W3F1-2016-0055

Subject: License Amendment Request to Revise Technical Specification 3/4.3.2 to Relocate Surveillance Frequency Requirements for Engineered Safety Features Actuation System (ESFAS) Subgroup Relays to the Surveillance Frequency Control Program (SFCP)
Waterford Steam Electric Station, Unit 3 (Waterford 3)
Docket No. 50-382
License No. NPF-38

**Waterford 3 Steam Electric Station
License Amendment Request to Revise Technical Specification 3/4.3.2
Analysis of Proposed Technical Specification Change and
Addition of New ESFAS Permissive Relays to the
Surveillance Frequency Control Program**

Revised (Markup) Technical Specification Pages

TABLE 4.3-2

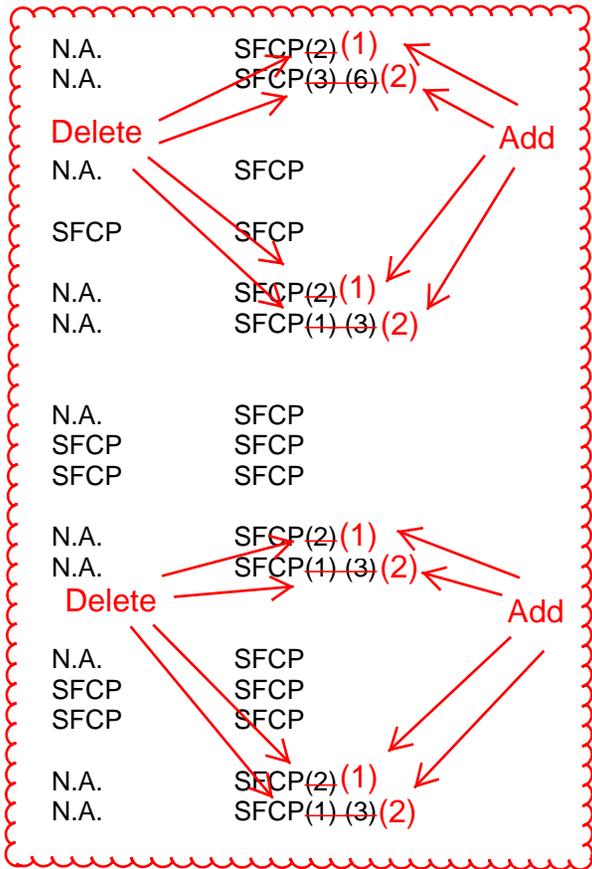
- Table Notation (1) will be deleted. Prior to Amendment 249, this annotated the Actuation Subgroup Relays that are tested on a staggered test basis. This staggered test basis surveillance frequency is now included in the SFCP, which is referenced in the table. The note is now redundant and is therefore not needed. The “Channel Functional Test” column in the body of Table 4.3-2 will be renumbered accordingly.

- Table Notation (2) will be renumbered to (1). The “Channel Functional Test” column in the body of Table 4.3-2 will be renumbered accordingly.
- Table Notation (3) will be renumbered to (2) and revised to delete the second sentence. The frequency for the relays that are not tested during power operation will be included in the SFCP. There will be no change to the first sentence. The “Channel Functional Test” column in the body of Table 4.3-2 will be renumbered accordingly.

Line Out

TABLE 4.3-2 (Continued)

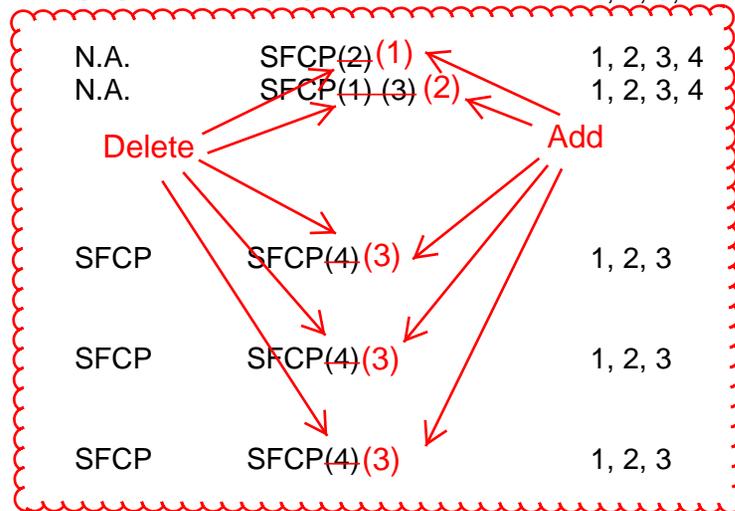
- Table Notation (4) will be renumbered to (3). The “Channel Functional Test” column in the body of Table 4.3-2 will be renumbered accordingly.
- Table Notation (5) will be deleted. The information in this note is a component of the surveillance frequency for the Control Valve Logic and will be included in the SFCP. References to Table Notation (5) in the “Channel Functional Test” column in the body of Table 4.3-2 will be deleted accordingly.

Line Out

TABLE 4.3.-2 (Continued)

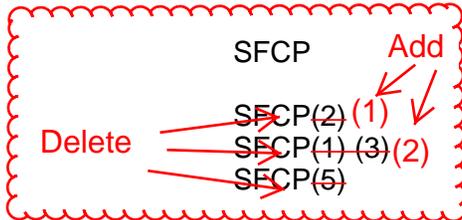
- ~~(1) Each train or logic channel shall be tested in accordance with the Surveillance Frequency Control Program.~~
- ~~(2) (1) Testing of Automatic Actuation Logic shall include the energization/deenergization of each initiation relay and verification of the OPERABILITY of each initiation relay.~~

- ~~(3) (2) A subgroup relay test shall be performed which shall include the energization/deenergization of each subgroup relay and verification of the OPERABILITY of each subgroup relay. Relays K109, K114, K202, K301, K305, K308 and K313 are exempt from testing during power operation but shall be tested in accordance with the Surveillance Frequency Control Program and during each COLD SHUTDOWN condition unless tested within the previous 62 days~~

- ~~(4) (3) Using installed test switches.~~
- ~~(5) To be performed during each COLD SHUTDOWN if not performed in the previous 6 months.~~
- ~~(6) Each train shall be tested, with the exemption of relays, K110, K410 and K412, in accordance with the Surveillance Frequency Control Program. Relays K110, K410 and K412 shall be tested in accordance with the Surveillance Frequency Control Program.~~

Renumber

Delete

Line Out

- (1) Testing of Automatic Actuation Logic shall include the energization/deenergization of each initiation relay and verification of the OPERABILITY of each initiation relay.
- (2) A subgroup relay test shall be performed which shall include the energization/deenergization of each subgroup relay and verification of the OPERABILITY of each subgroup relay.
- (3) Using installed test switches.
